Pollard Street

Section 73 Addendum to Accompany
Design and Access Statement

December 2023

Hawkins\Brown

Typical Upper Floor Plan

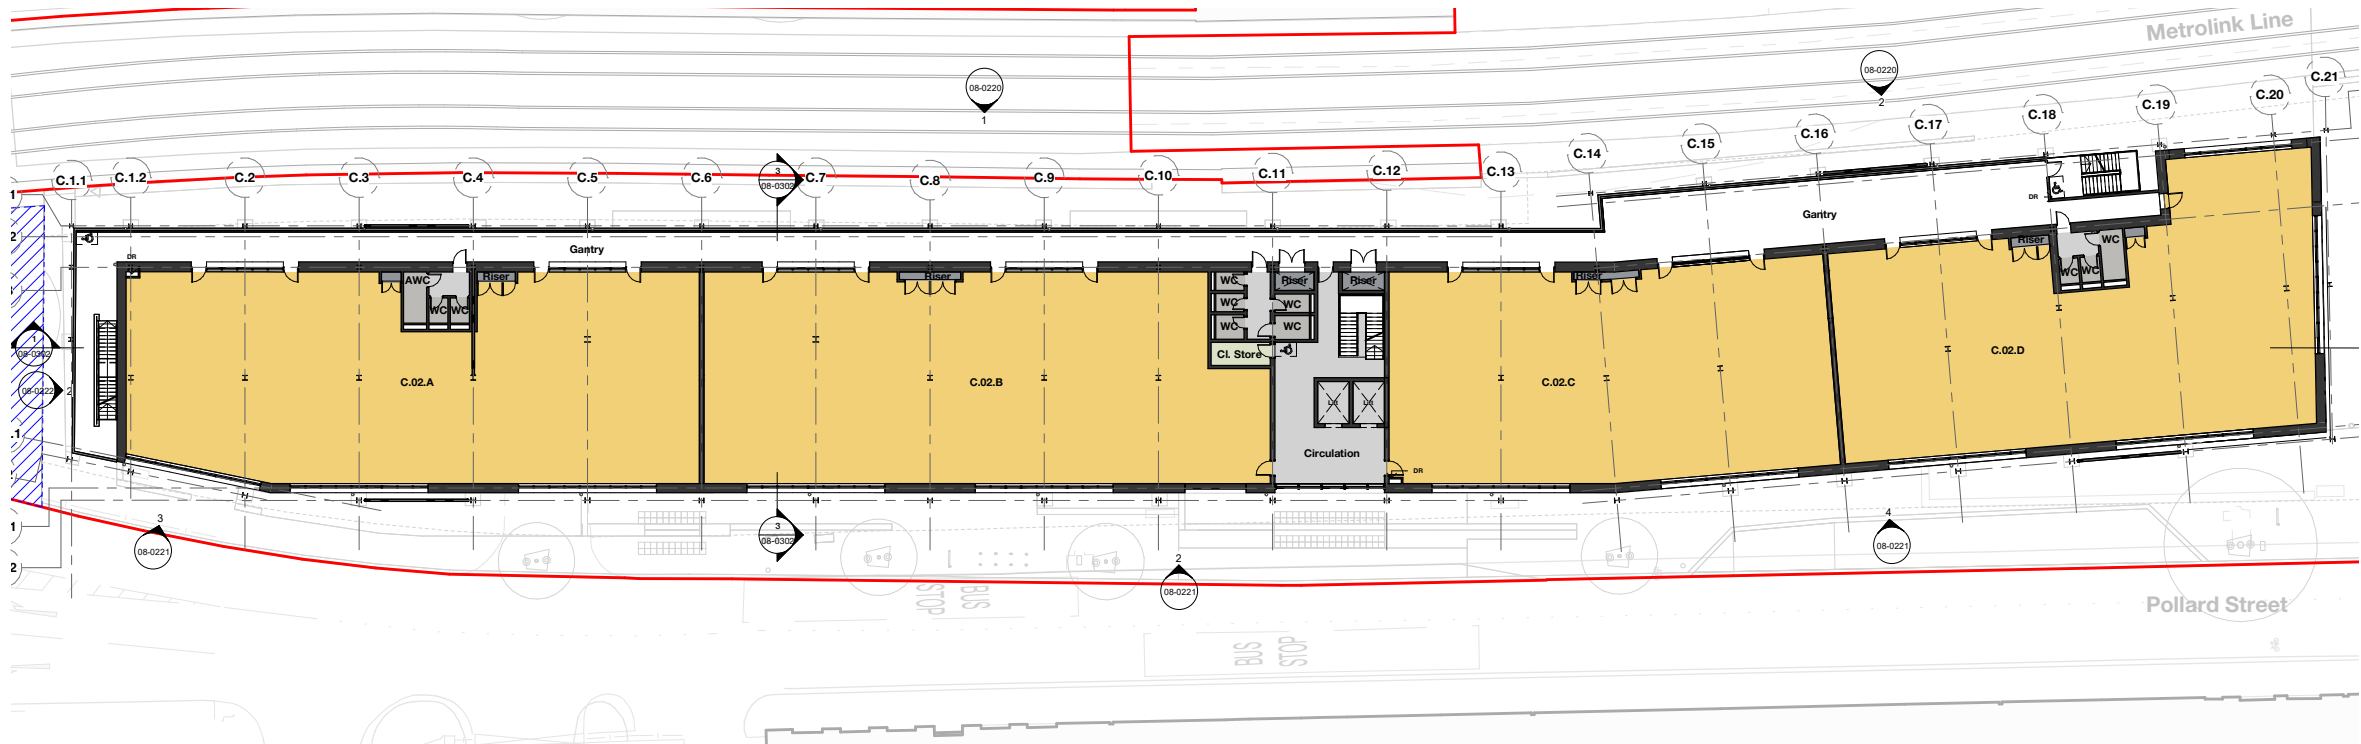
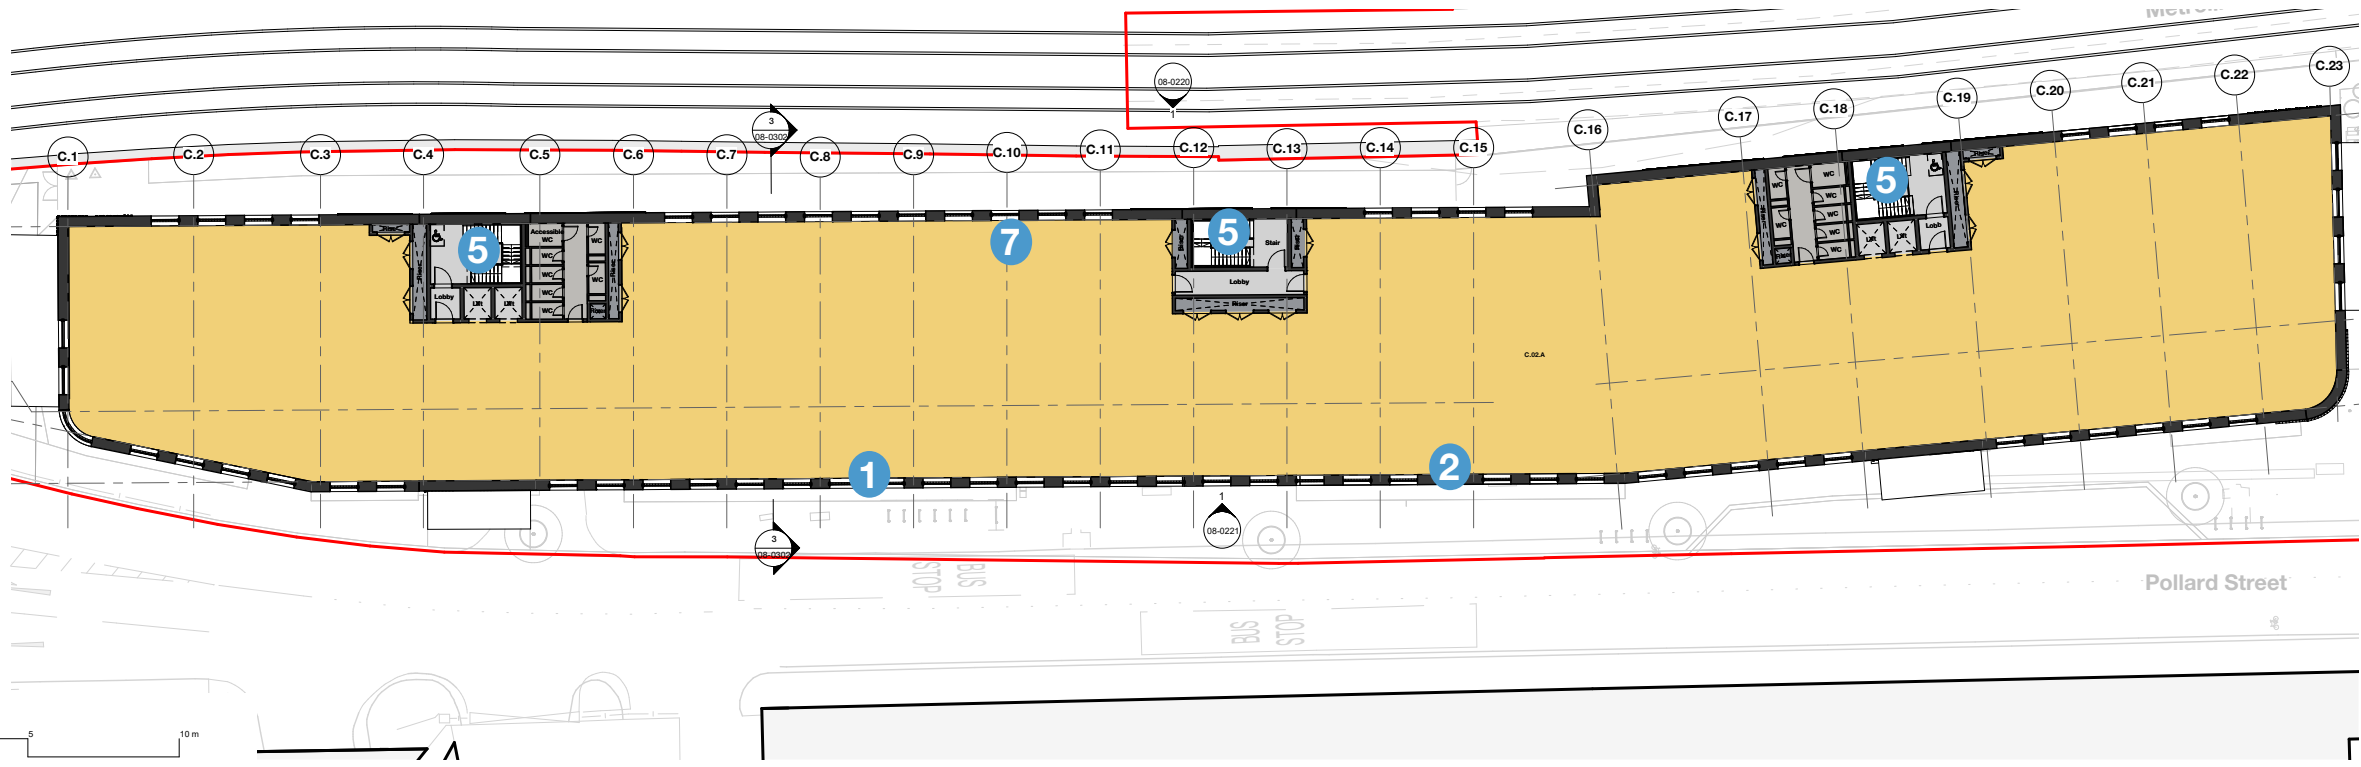
- 1. Primary façade cladding changed from metalwork to brickwork
- 2. Window arrangement updated
- 3. Main workspace entrance relocated
- 4. Ground floor access relocated
- 5. Core / circulation strategy updated
- 6. Internal layout updated
- 7. External gantry / access deck omitted
- 8. Position of plant screen updated
- 9. Roof access updated

Roof Plan

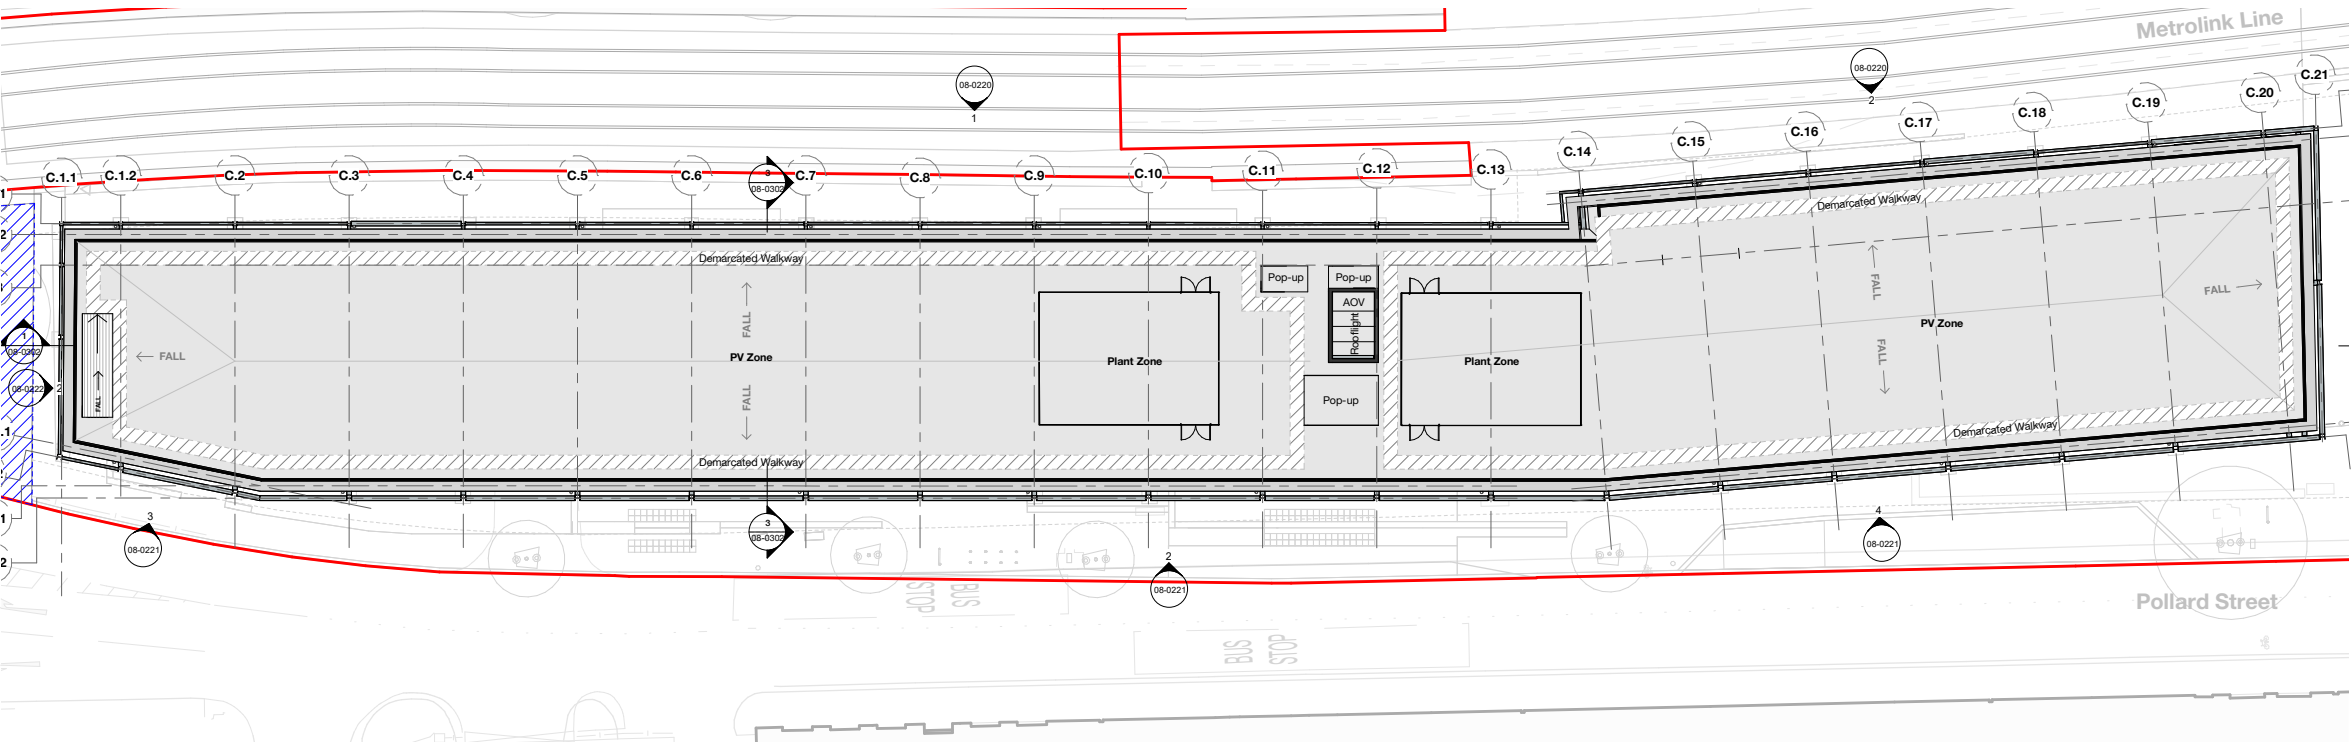
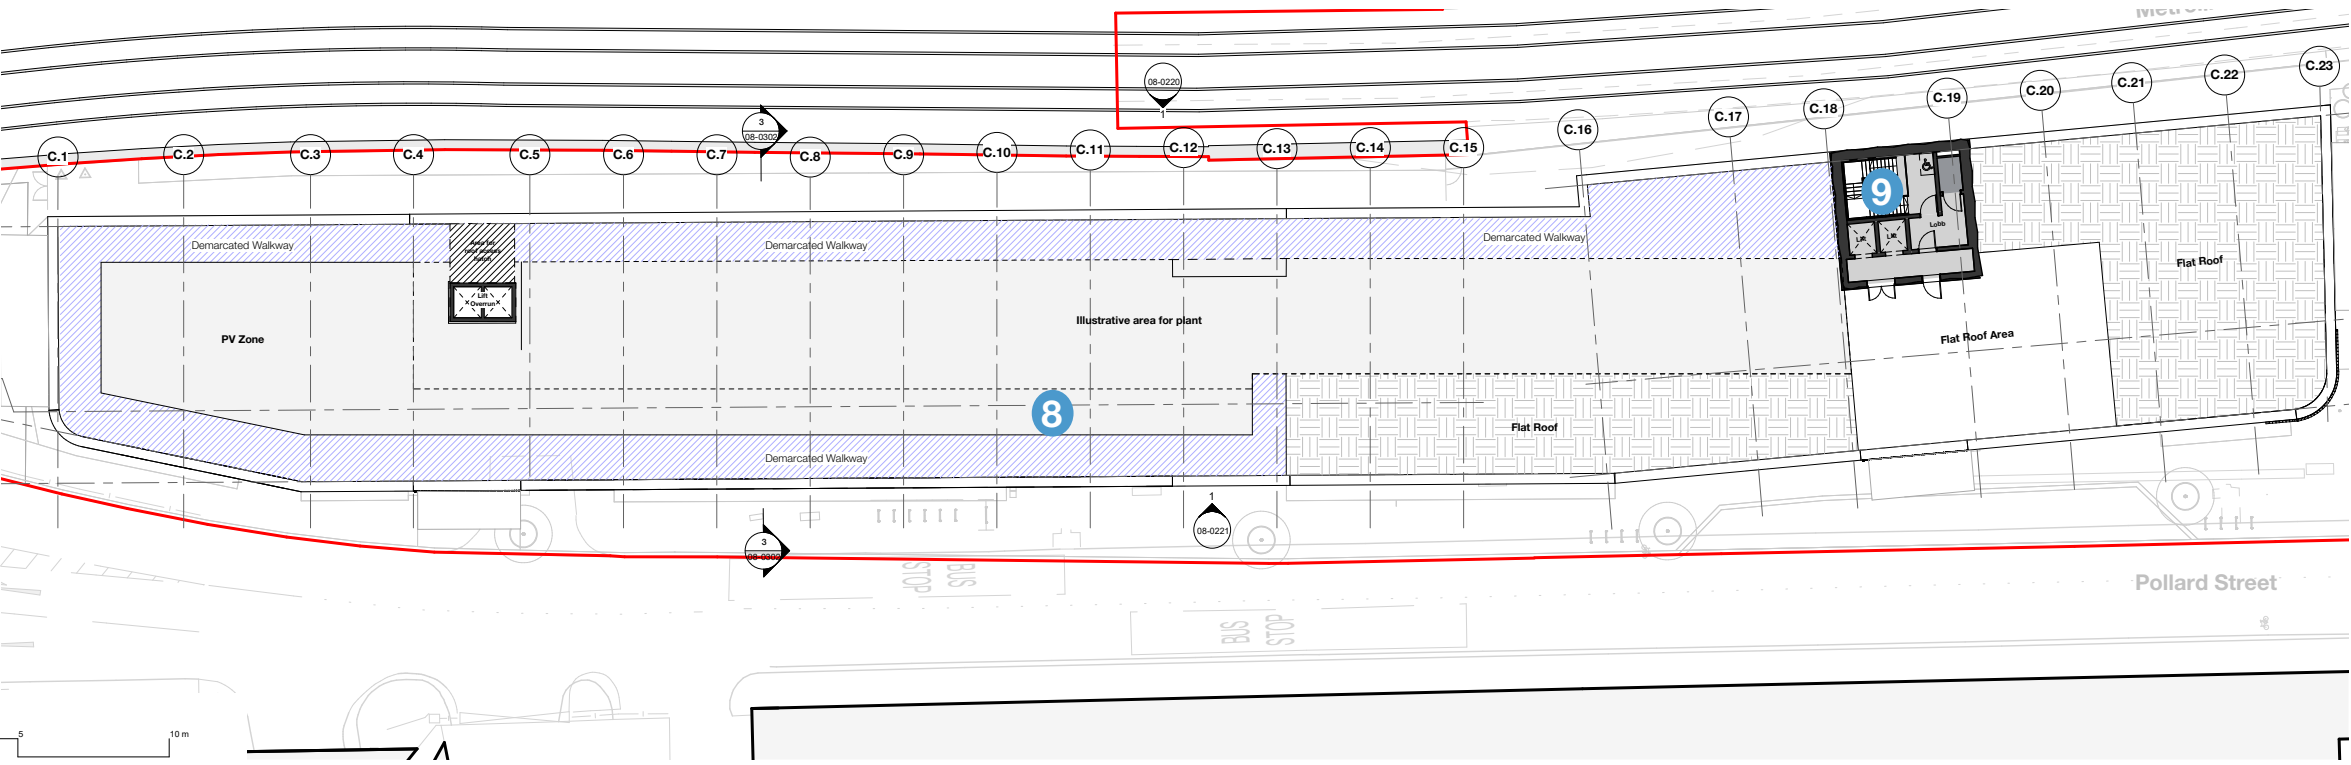
- 1. Primary façade cladding changed from metalwork to brickwork
- 2. Window arrangement updated
- 3. Main workspace entrance relocated
- 4. Ground floor access relocated
- 5. Core / circulation strategy updated
- 6. Internal layout updated
- 7. External gantry / access deck omitted
- 8. Position of plant screen updated
- 9. Roof access updated

7.3 First Floor Plan

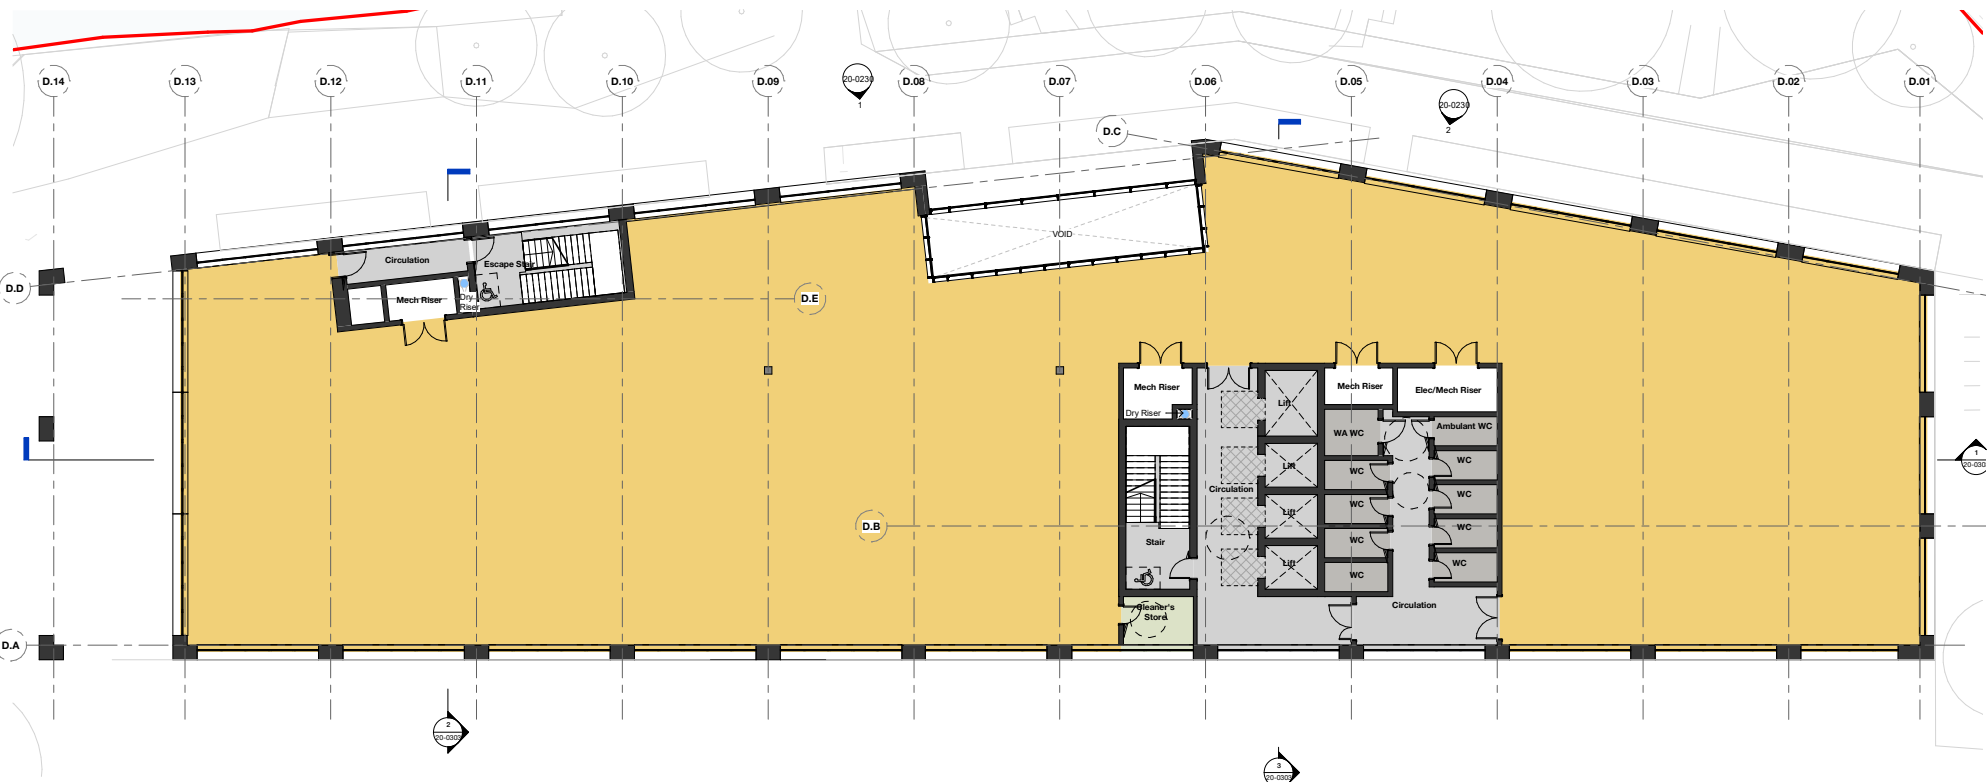
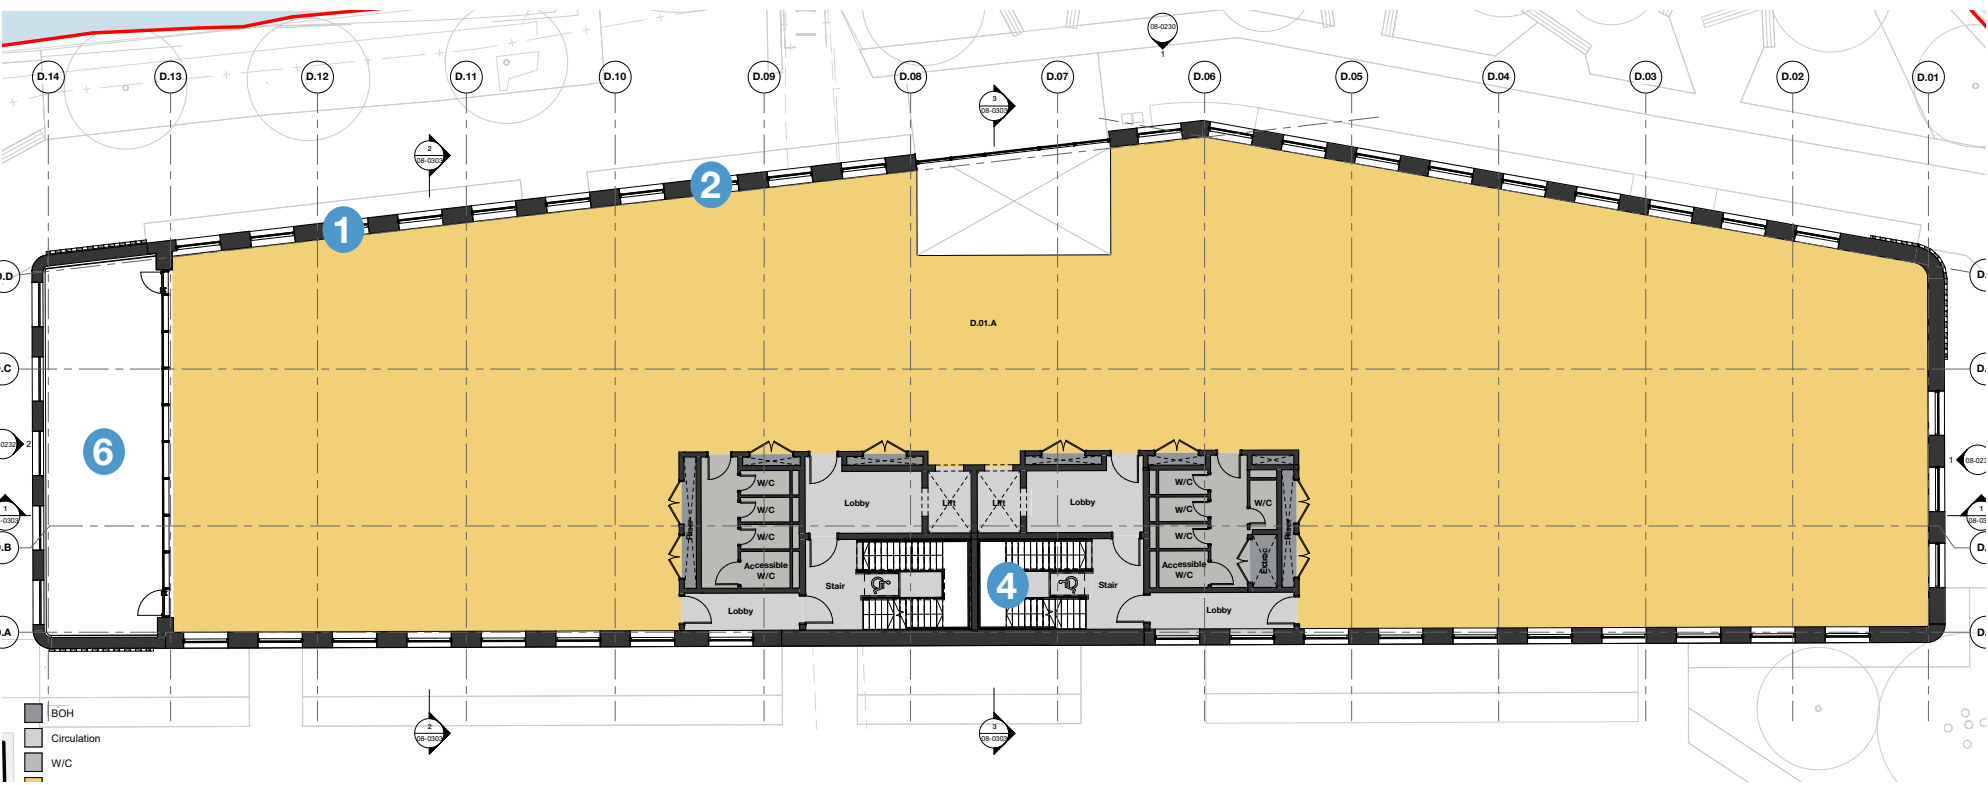
- 1. Primary façade cladding changed from metalwork to brickwork
- 2. Window arrangement updated
- 3. Ground floor access relocated
- 4. Second stair relocated within the central core
- 5. Internal layout updated
- 6. External gantry replaced with external terrace
- 7. Roof terrace relocated
- 8. Position of plant screen updated
- 9. Roof access updated
